EXHIBIT 2: SCOPE OF WORK/ TECHNICAL SPECIFICATIONS

Alachua County Solid Waste and Resource Recovery Solid Waste Transfer Station Repairs Alachua County Bid: ITB-22-308-TW Jones Edmunds Project No.: 01560-150-01

The Contractor submitted a revised price proposal based on the County's priorities in the correspondence dated May 23, 2022, attached. The Contractor's letter contains six bullet items identifying the changes in work included in the Contractor's Revised Price Proposal. Jones Edmunds has provided comments regarding the changes as follows:

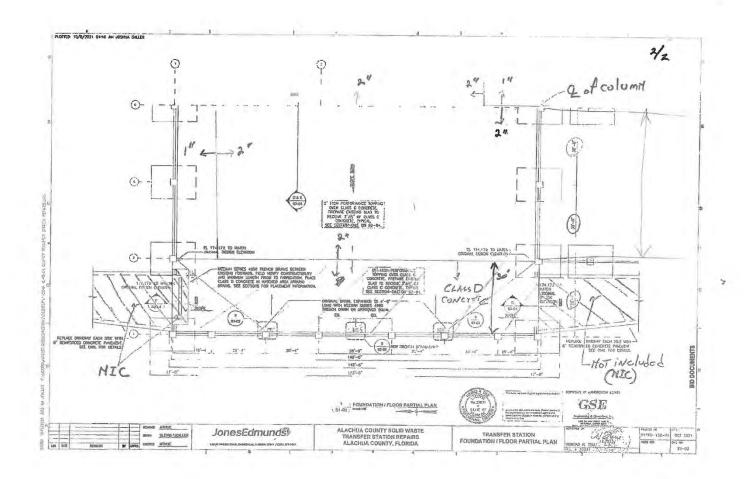
- 5. Revised Limits of Heavy-Duty floor topping. The limits and thickness of the high-performance floor toppings have been revised as shown in the revised project drawings. The location and thickness of the heavy-duty topping has been changed to reduce the amount of the topping. In addition, the 30-feet wide drive lane between the entrance and exit doors has been changed from heavy duty topping to a minimum thickness of 6 inches of Class D concrete. This change will not affect achieving the primary project goals

- 4. Delete all painting.
- 5. Revised the High Performance Floor Topping- The limits and thickness of the high-performance topping has been revised. This includes eliminating the high-performance topping in the truck driving lane inside the transfer station and using Class D (8000 psi silica fume with granite aggregate). Class D concrete in the driving lane shall have a minimum of 6 inches thick. The limits of the three different topping thicknesses are approximately shown on the attached figure.
